# UNITED STATES PATENT AND TRADEMARK OFFICE

**Office Action Summary**

10/792,326

### **DETAILED ACTION**

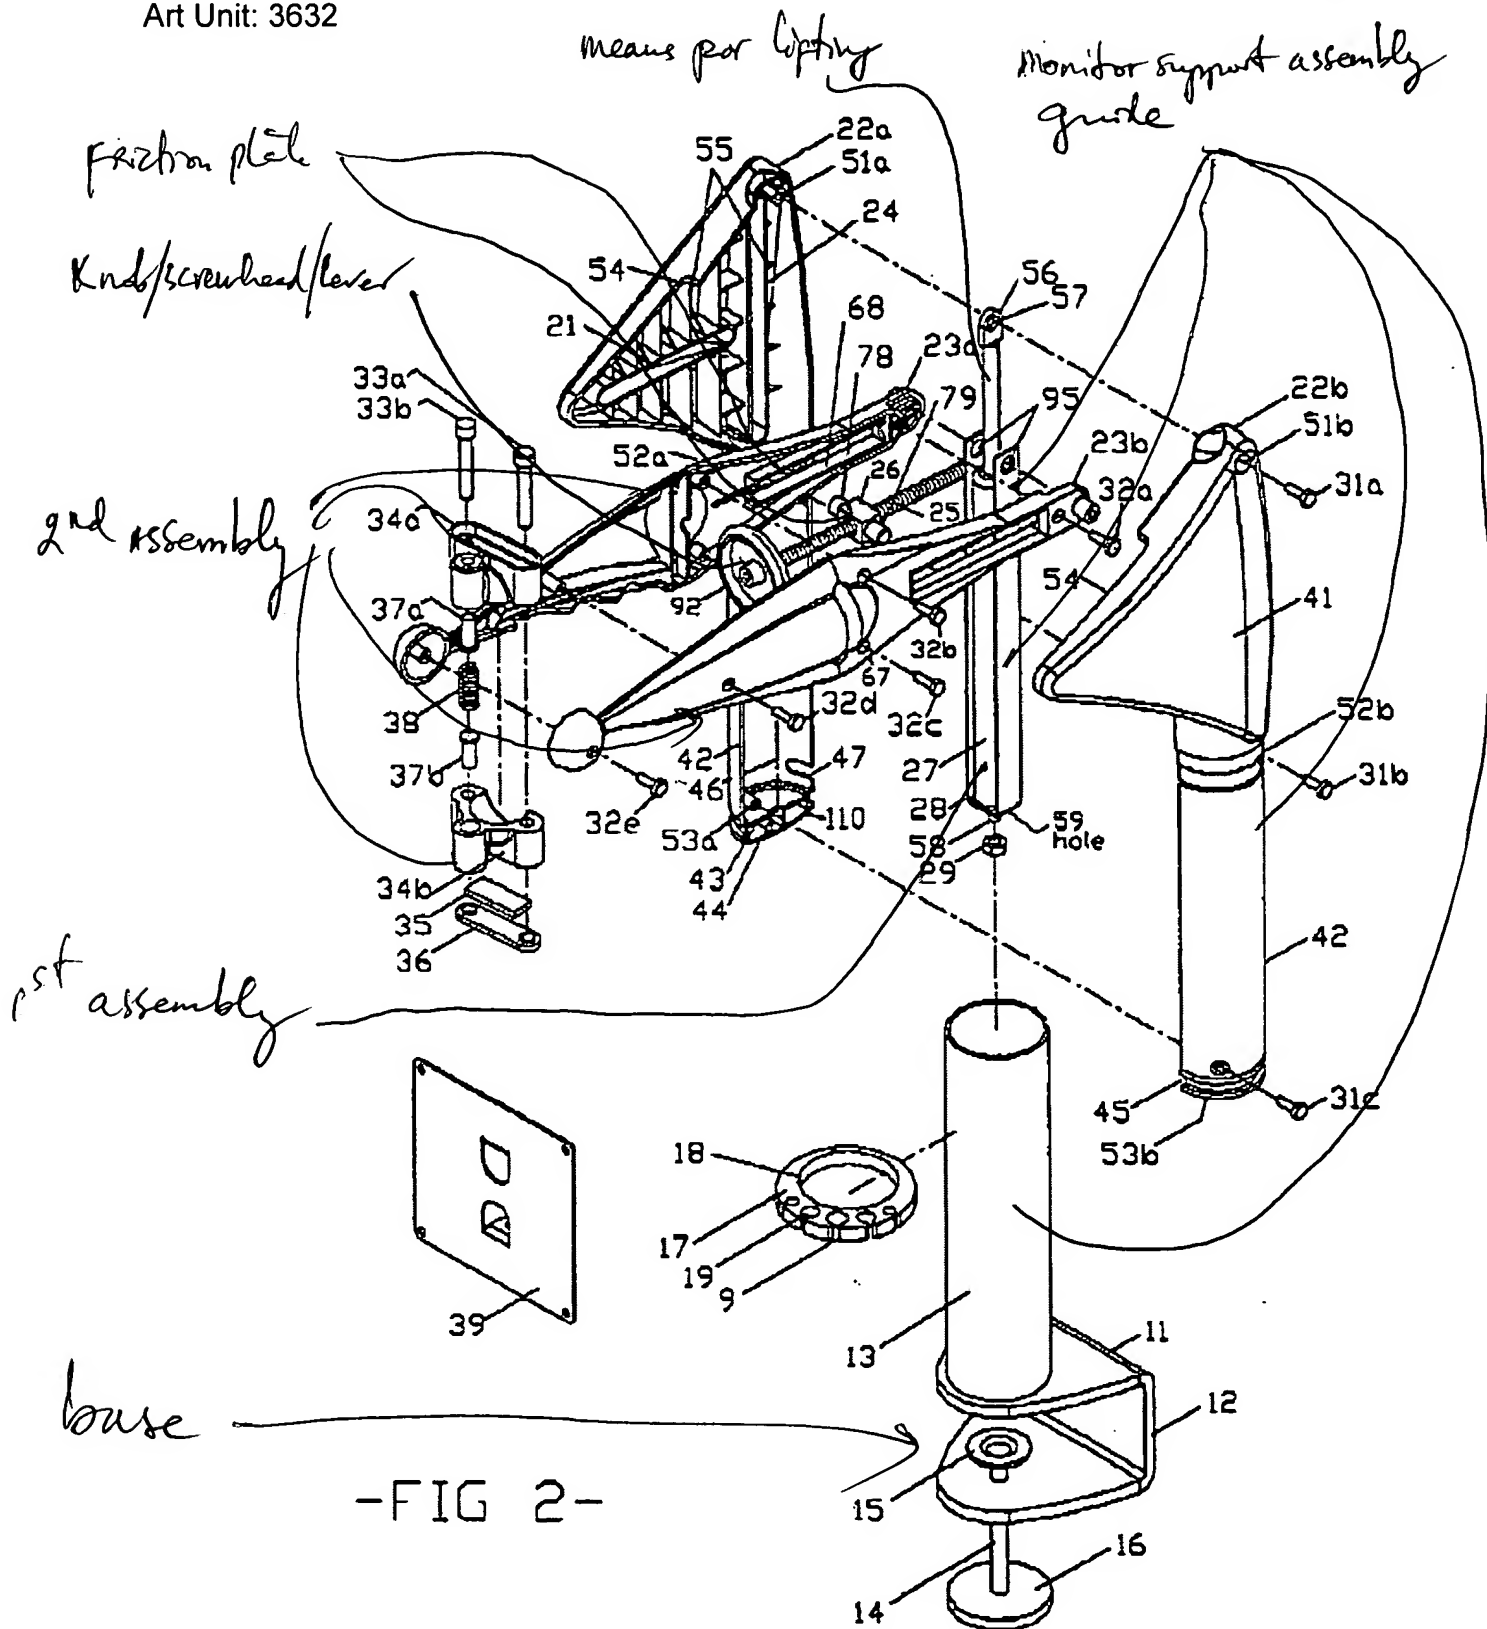
Claims 1-20 are rejected under 35 U.S.C. 102(e) as being anticipated by US Patent No. 6,857,610 to Conner et al.

All limitations in claims 1-20 are substantially disclosed in the prior art of Conner et al as illustrated below.

Note: regarding claims 3-4, 10-11 the monitor support assembly of Conner et al. can be moved vertically by applying a force with a vertical component of more or less than 10 Newtons.
